**City of Phoenix**  
PLANNING AND DEVELOPMENT DEPARTMENT

**Staff Report Z-57-19-1**  
**March 9, 2020**

C-2 HGT / DNS / WVR (Intermediate Commercial, Height Waiver, Density Waiver) (7.32 acres)

Multifamily Residential

Figure C: Conceptual Site Plan

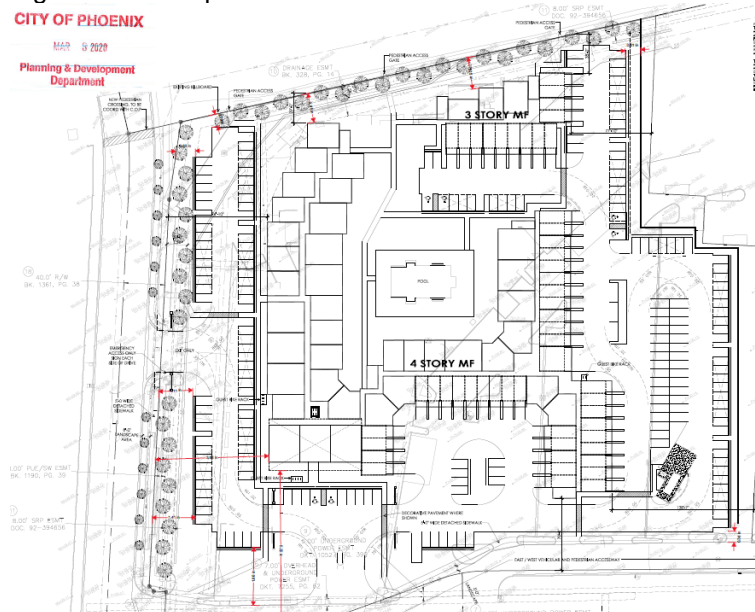
The site plan depicts units oriented closely to the canal, three access controlled pedestrian gates onto the canal from the site, and a broad setback area created by the flood control easement where trees can be planted. Staff is recommending a series of stipulations to activate the canal:

- a. A limitation on solid perimeter walls to the north and west greater than 40 inches in height (Stipulation No. 10).
- b. A requirement for three pedestrian gates onto the canal (Stipulation No. 12.a.).
- c. A requirement that a minimum of 30 residential units be oriented to the canal with a pedestrian oriented ground floor frontage, upper floor windows, and balconies for 40 percent of units (Stipulation No. 12.b.).
- d. A requirement for enhanced tree planting standards in the north setback area (Stipulation No. 12.c.).
- e. A requirement for visual design continuity between the central amenity area and the canal (Stipulation No. 12.d.). This complements Stipulation No. 8 which requires a pedestrian connection between these locations.

The site plan depicts several pedestrian amenities which are desirable given the location both in the North Mountain Village Core and adjacent to the Arizona Canal. Staff is recommending a series of stipulations related to pedestrian orientation:

- a. Stipulation No. 3 requires a pedestrian and vehicular accessway extending from 29th Avenue on the west approximately 400 feet east into the remainder of the shopping center; this pedestrian pathway will be detached from the vehicular circulation areas.
- b. Stipulation No 7 requires detached sidewalks along 29th Avenue with enhanced tree plantings between the curb and sidewalk.
- c. Stipulation No. 9 requires that all public and private pathways including public

- d. Stipulation No 8 requires a series of three pedestrian pathways which connect the building to 29th Avenue at both the northwest and south west corners of the site and to the Arizona Canal.

The site plan depicts less parking than required by the Zoning Ordinance. The ordinance allows an applicant located within a Village Core or within proximity to high-capacity transit to seek relief from these provisions.

The site plan depicts a broad landscape area between 29th Avenue and the parking lot. Staff is recommending a stipulation requiring the landscape setback along 29th Avenue be an average of 30 feet and be planted to enhanced standards (Stipulation No. 6). In concert with the detached sidewalks and enhanced tree plantings between back of curb and sidewalk, this will create a lush and well shaded pedestrian environment. Additional detail is contained in Background Item No. 14: Tree and Shade Master Plan.

Figure D. Conceptual Building Elevations (Top, 29th Avenue Elevation) (Middle, Canal Elevation) (Bottom, South Elevation)

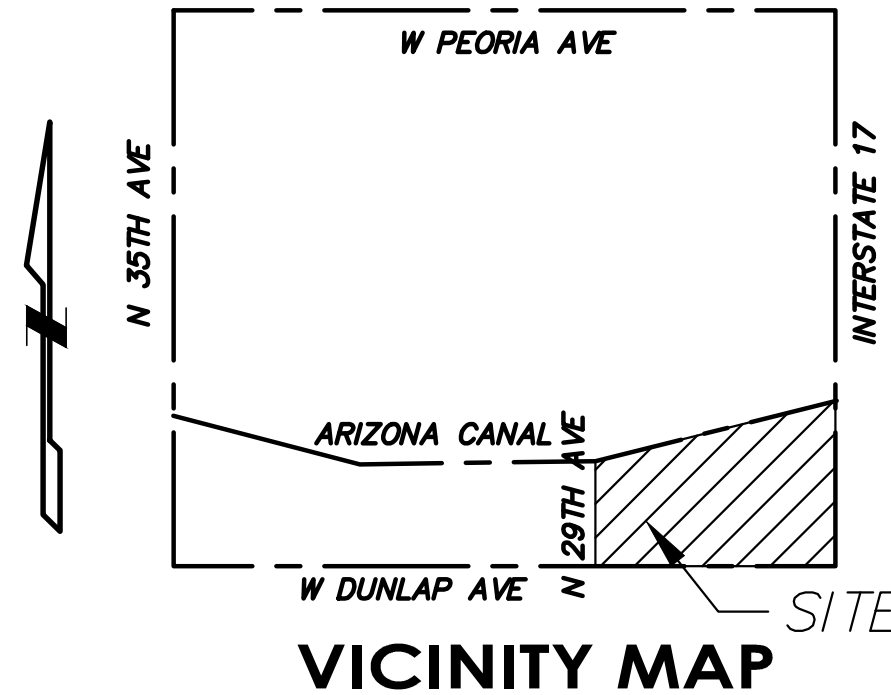
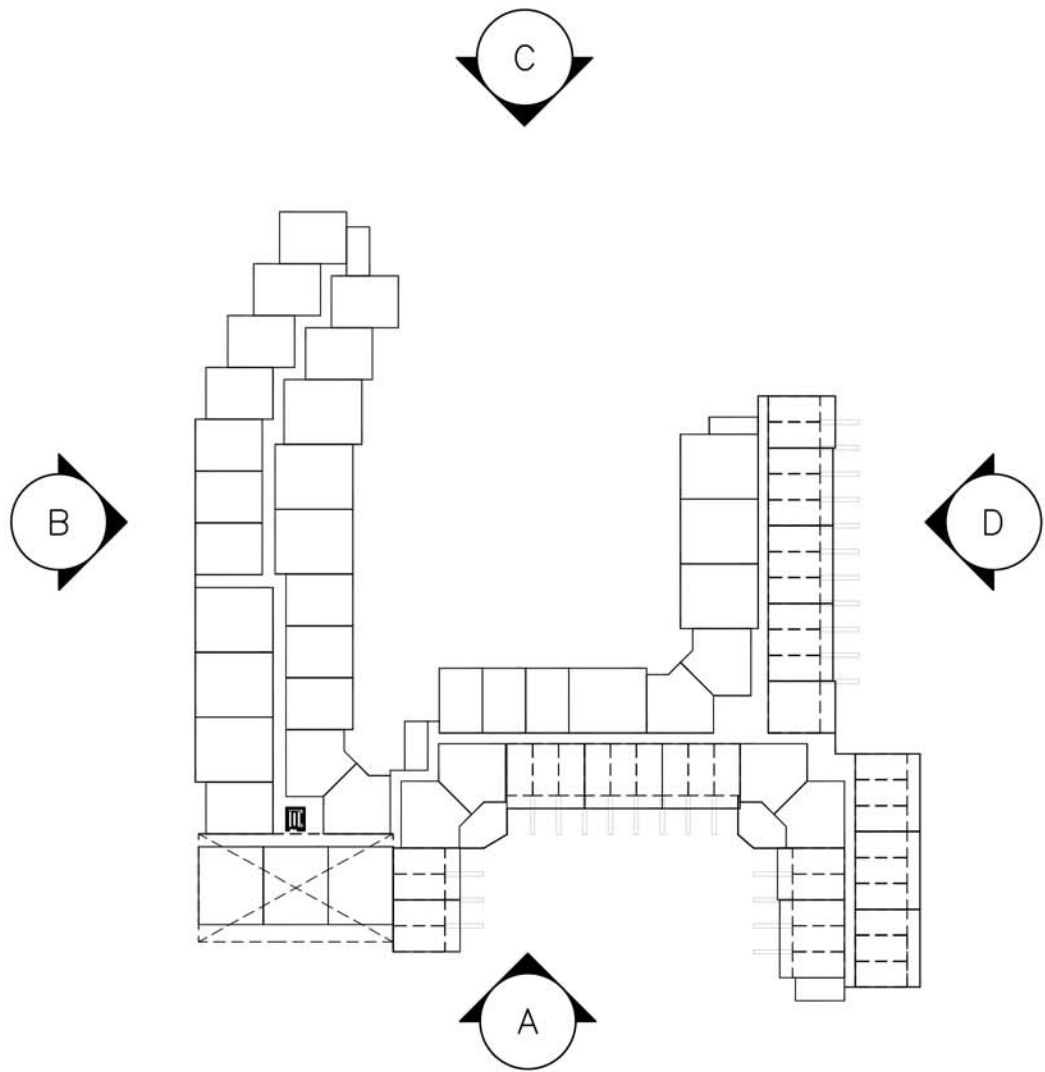
The applicant prepared conceptual building elevations which include a mix of colors, textures, offsets, and recesses. The elevations also depict upper floor balconies and ground level patios.

11. Staff is recommending a series of stipulations related to the building elevations to promote an environment conducive of walking, bicycling, and transit use.

- a. Architectural embellishments (Stipulation No. 4): The intent of this stipulation is to add visual interest and additional design consideration later in the site plan review process.

- b. Prominent corners at the northwest and southwest corner of the building mass (Stipulation No. 5): The intent of this stipulation is to add visual interest to the building, form a connection between the building, the canal, the street, and the remainder of the North Mountain Village Core north of the canal.

- c. Individual garage entrances shall not be visible from the north and west site boundaries (Stipulation No. 13)
  - d. Requiring porches and patios along the north and west frontages of the building to facilitate additional pedestrian interaction with the street, canal, and surrounding environment. These are addressed in Stipulation Nos. 11 and 12 respectively with examples contained in Figure D.
